DESIGN & ACCESS STATEMENT

Manor Lodge
Rickmansworth Road
Northwood
Middlesex

Demolition of the existing structures and creation of 6 family residential units together with means of access and associated parking and landscaping.

PRE-APP SUBMISSION

1 PROPOSED SITE PLAN
1 : 200

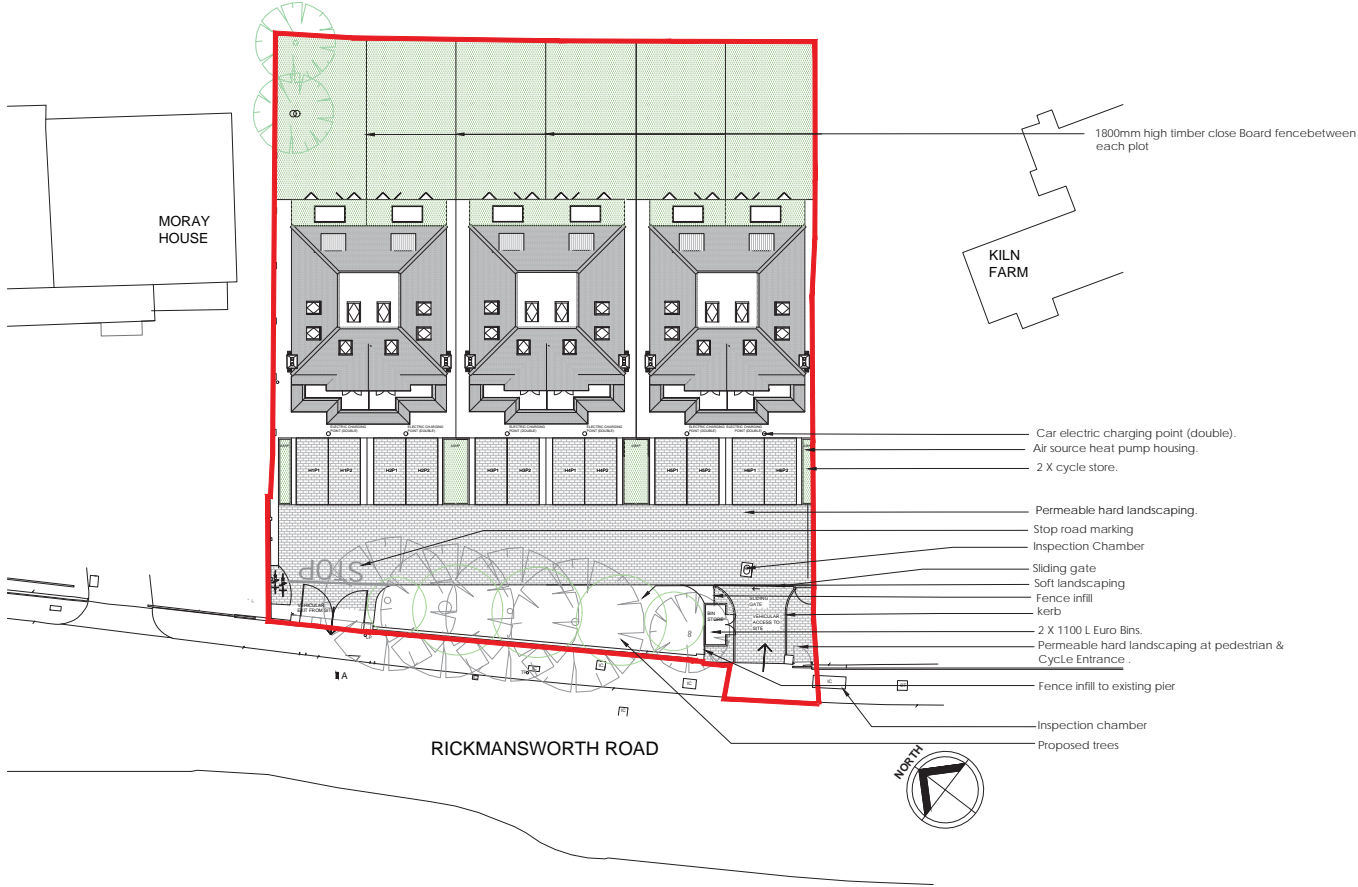
| Officer Comments | Design Response February 2024 |
|---|---|
| Siting not in keeping with prevailing character | Revised scheme is now positioned 5m further back in the site from the front site boundary and includes 4m deep front gardens together with an additional 0.5m gap between each unit and the respective flank boundaries. |
| Layout not in keeping with prevailing character | Revised scheme is now positioned 5m further back in the site from the front site boundary and thus set further back in relation to the front building line of Moray House together with an additional 0.5m introduced between flank boundaries of each property, Moray House and Kiln House . |
| Excessive hard standing | Enhanced boundary screening and an increased front garden area of 4m in depth now introduced in this revised scheme. |

PROPOSED
GROUND FLOOR PLAN

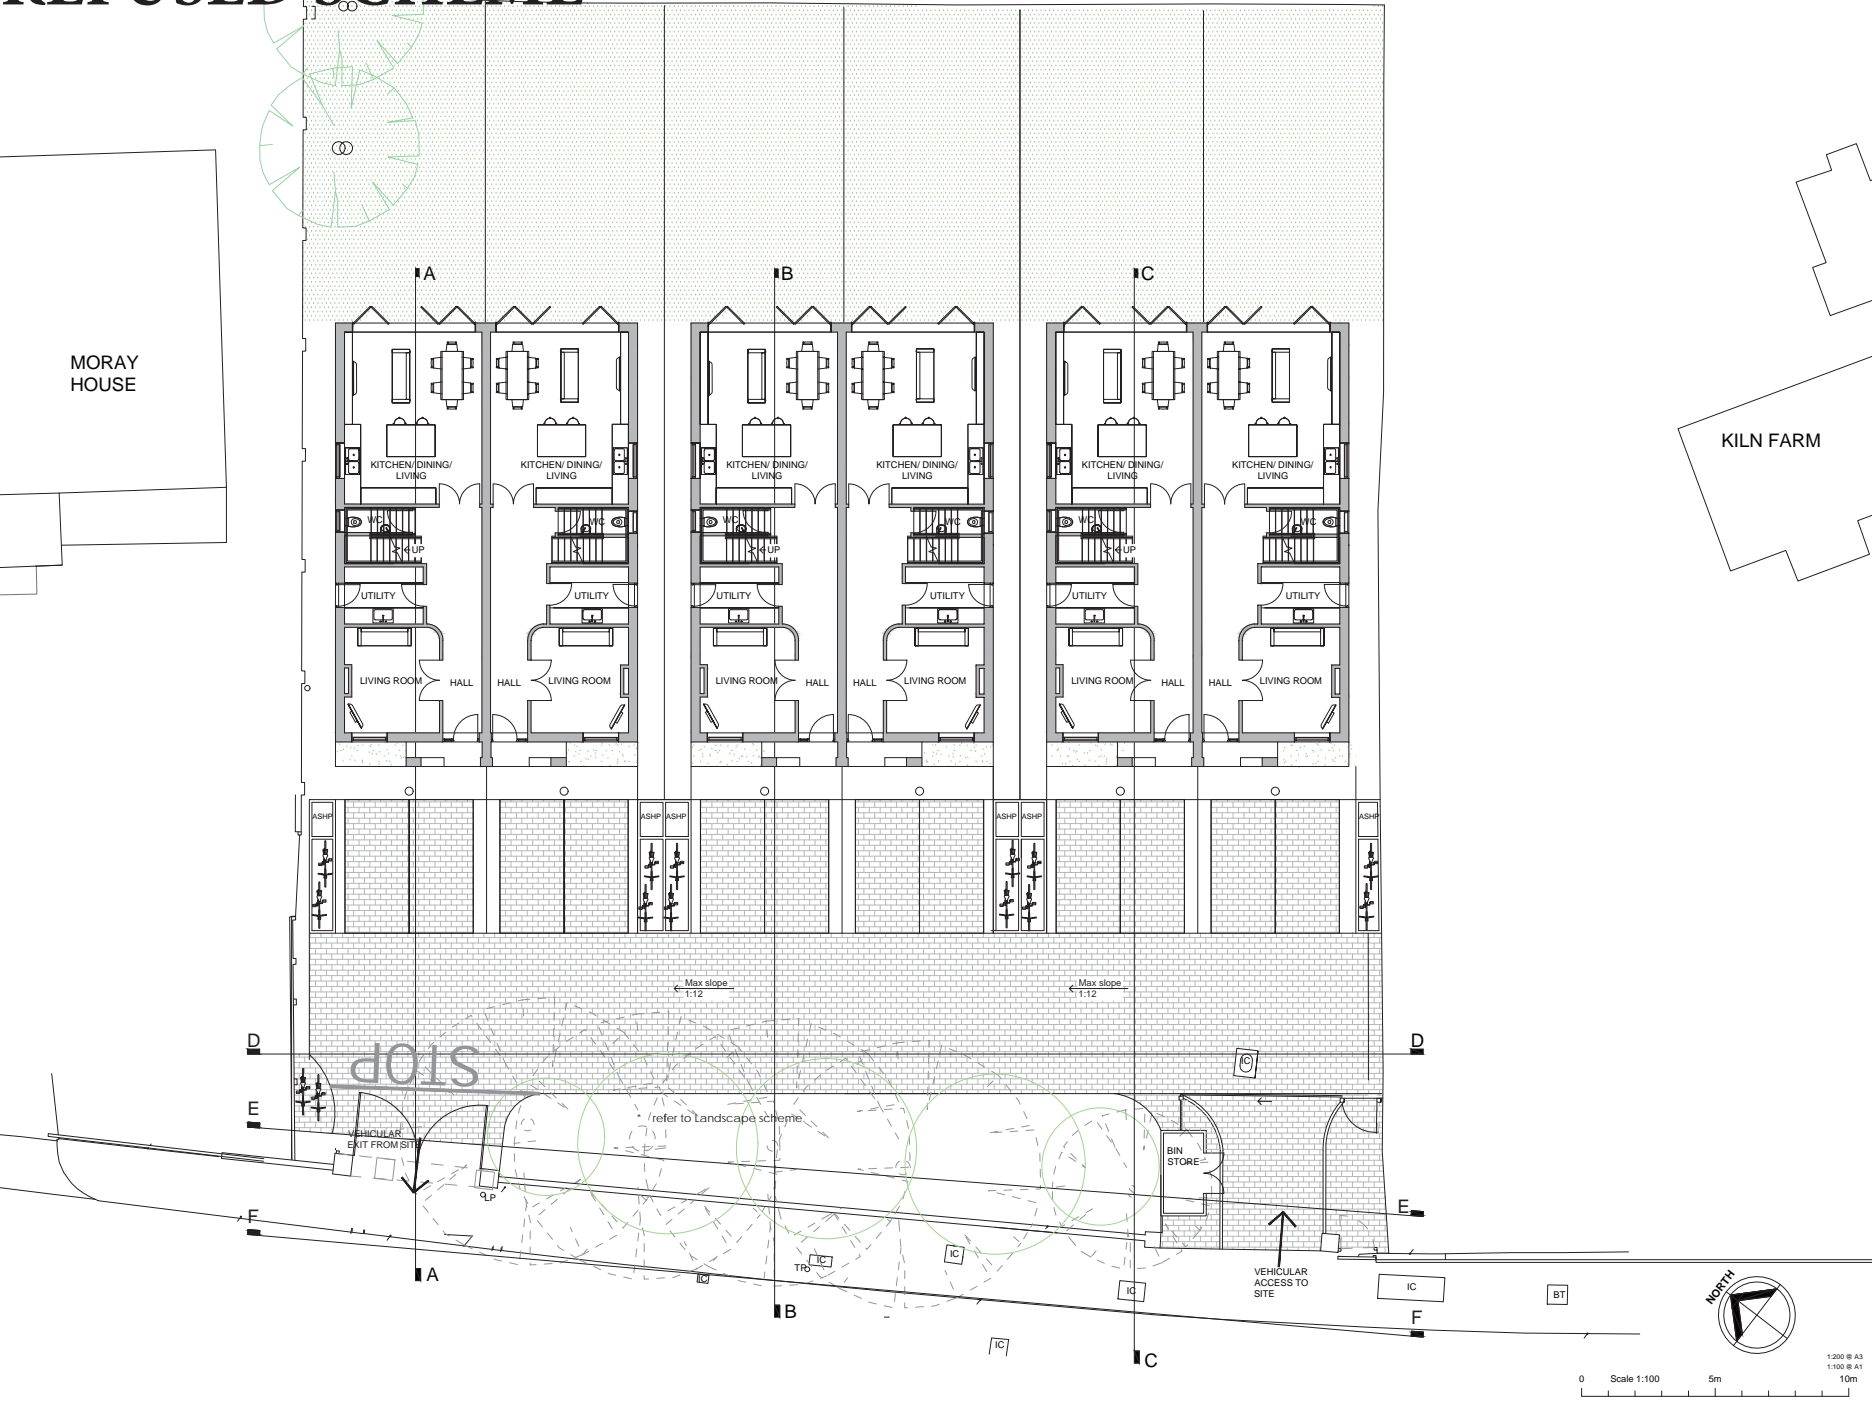
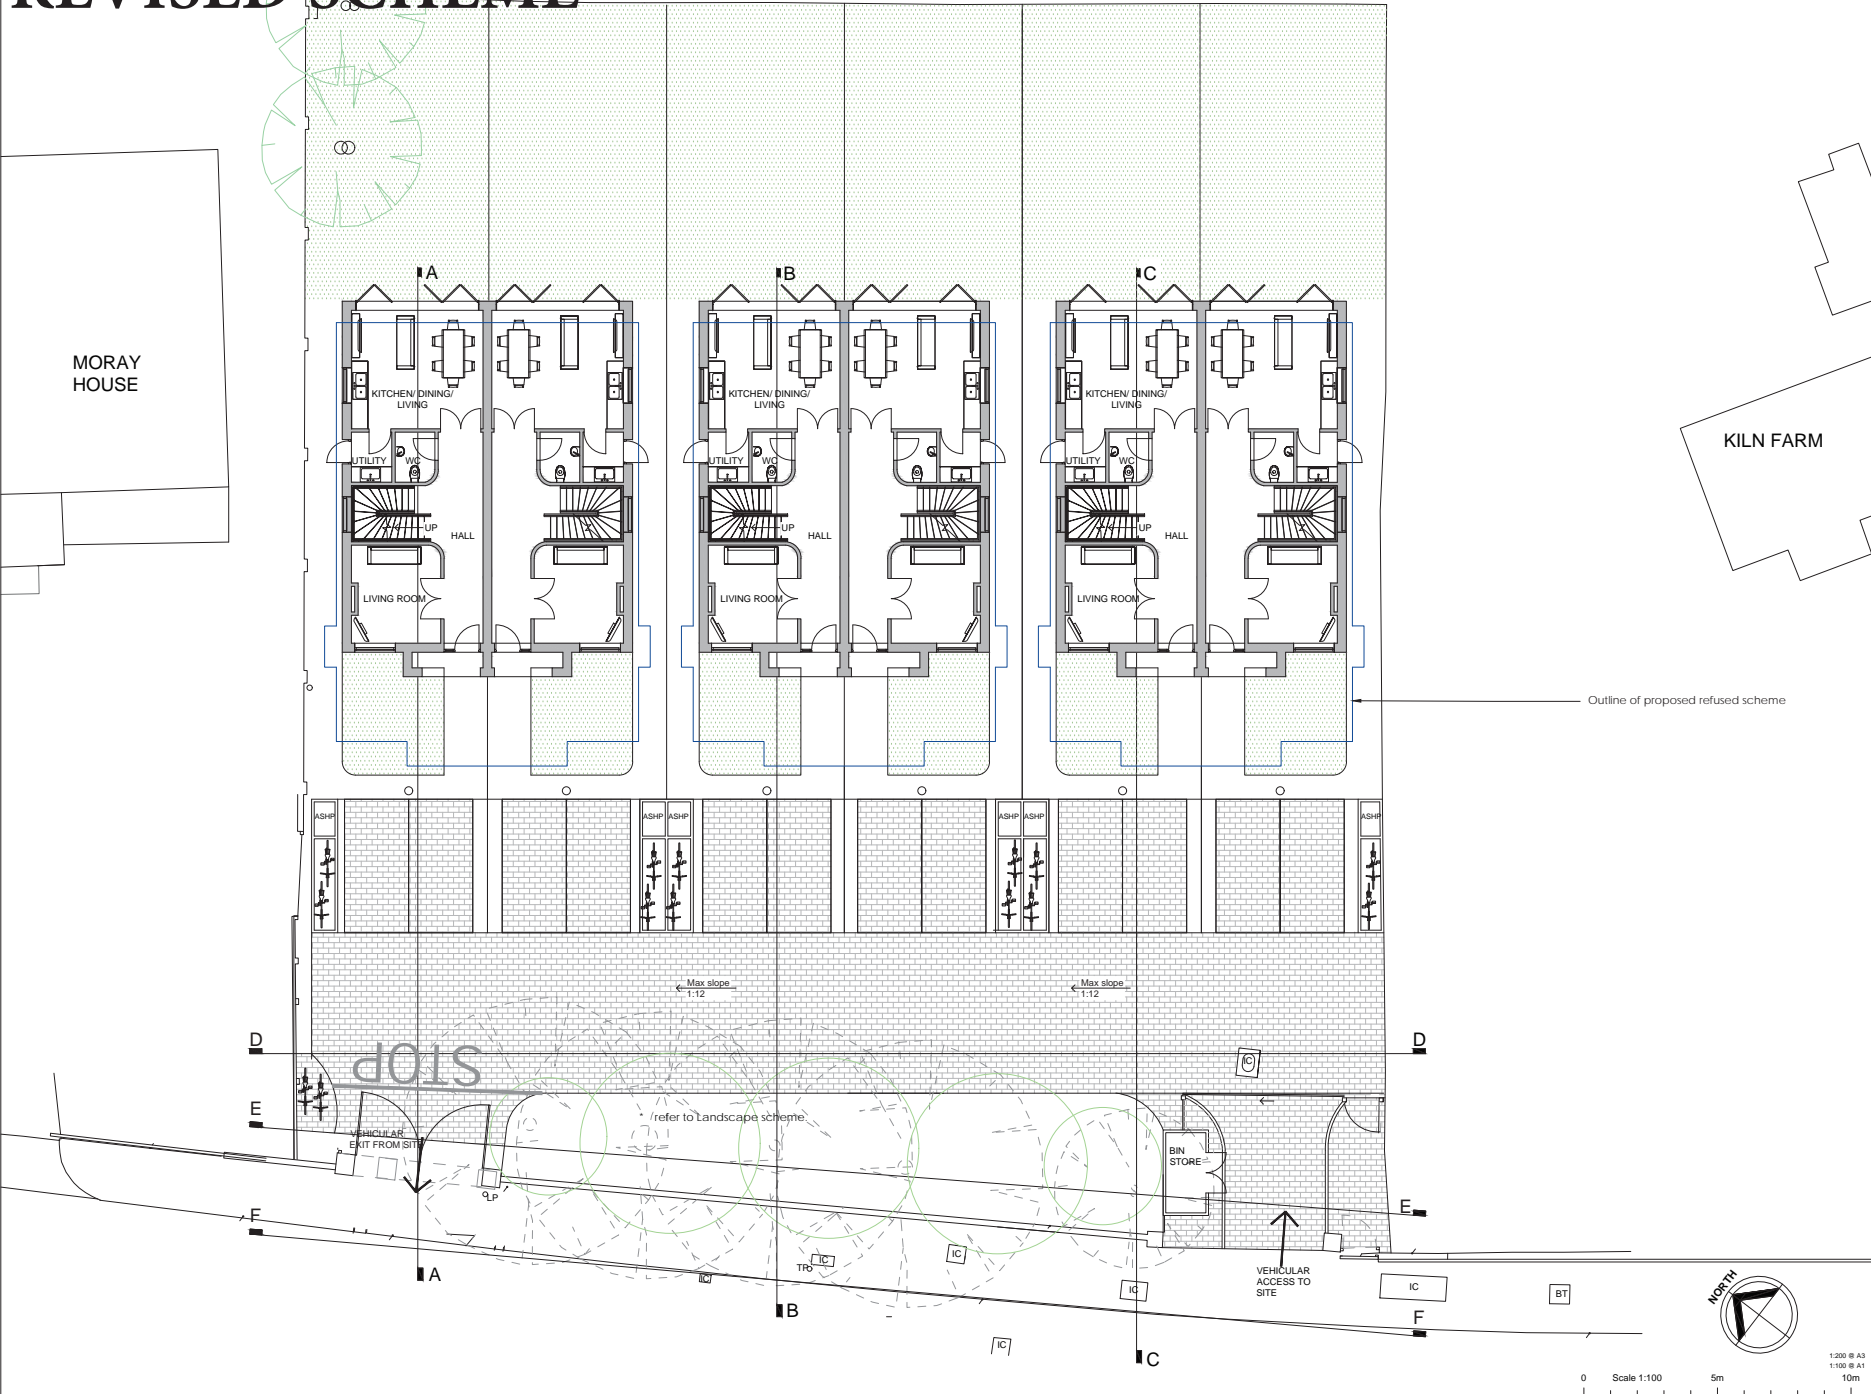
| Officer Comments | Design Response February 2024 |
|---|---|
| Size not in keeping with prevailing character | Revised scheme has reduced the size and footprint / depth of each dwelling to accommodate the additional 5 metres distance away from the front site boundary line. |
| Scale not in keeping with prevailing character | Revised scheme now reflects original Pre-App scheme with a flush 2-storey front elevation, less depth and smaller crown roof / greater pitched roof. |

Drawing
PROPOSED ELEVATIONS

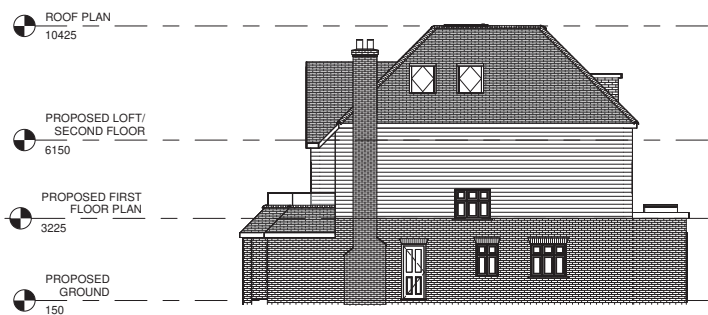
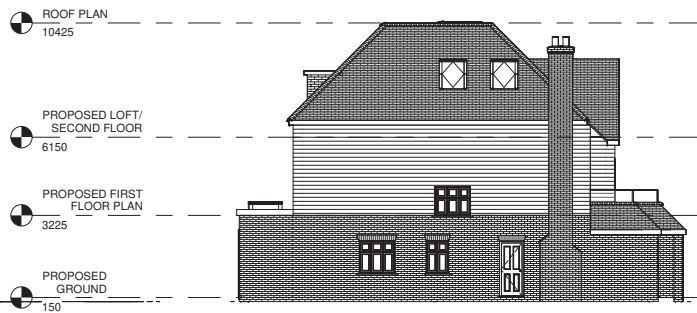
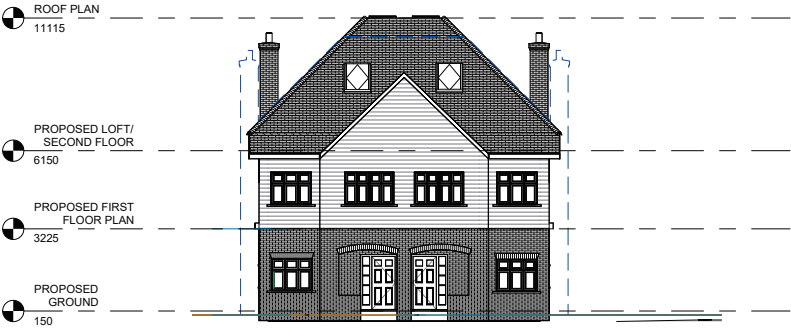
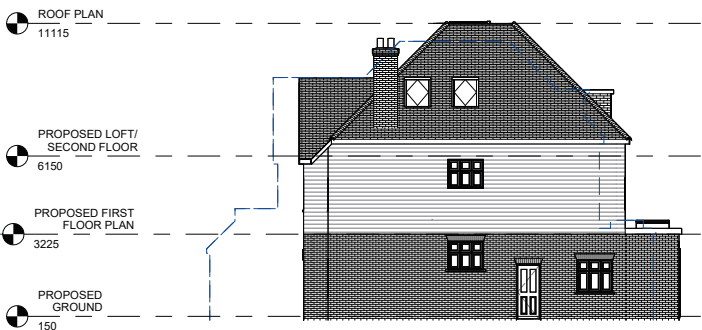
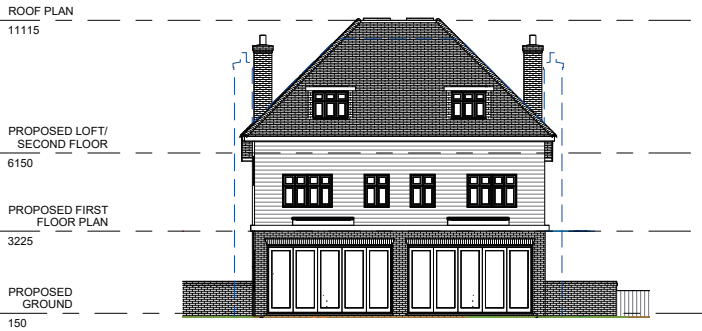
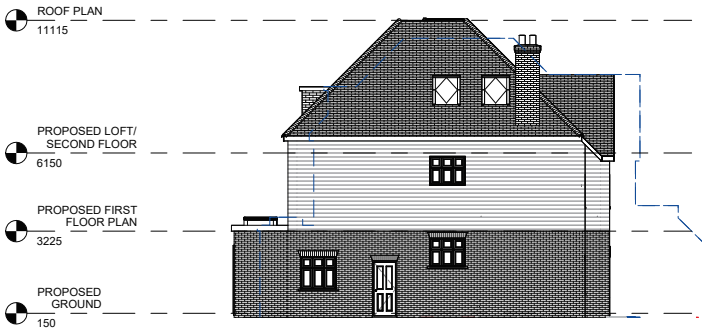
| Officer Comments | Design Response February 2024 |
|---|---|
| Appearance – gable frontage, pulled out first floor, sloped form, balconies, windows and crowned roof incongruent with prevailing character | Revised scheme now provides a 2-storey flush front elevation, omits the stepped first floor / balconies and French doors to the front elevation, includes traditional windows and swept head brickwork over front door. |

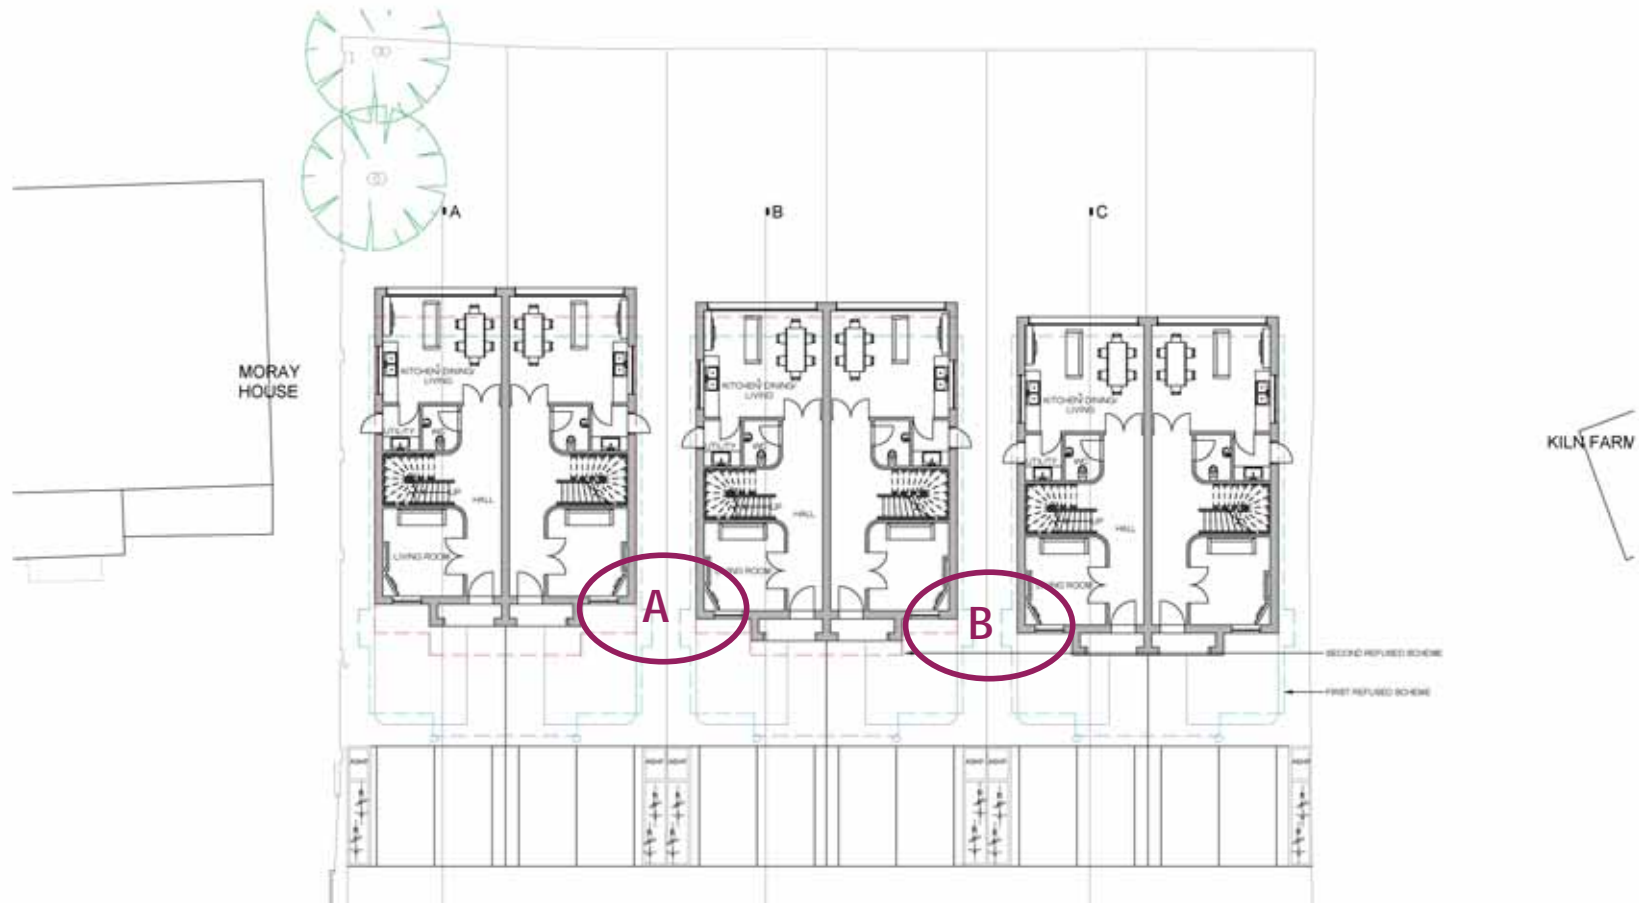
| Staggered building line to frontage in lieu of an increased separation to flank walls not being feasible. | The front building line is now slightly staggered. The far left hand house is set back furthest by ~1.2 metres (A) and the middle house by ~0.6 metres (B). This breaks up the perceived mass and also provides a suitable response and relationship with the neighbouring building lines to the north and south. | |

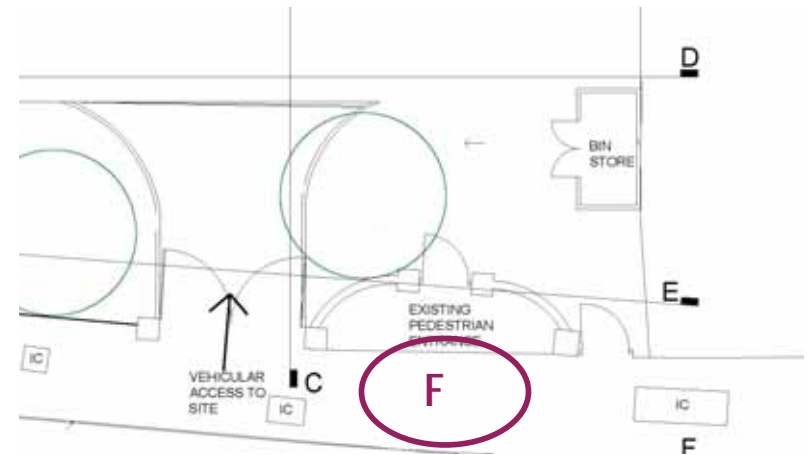
| It is advised that the existing semi-circular pedestrian entry point towards the boundary shared with Kiln Farm is retained as a visual feature of the site. | | The proposed vehicular access has been repositioned to allow for the retention and re-use of the semi-circular brick pedestrian entrance as a retained feature of the site (F). |
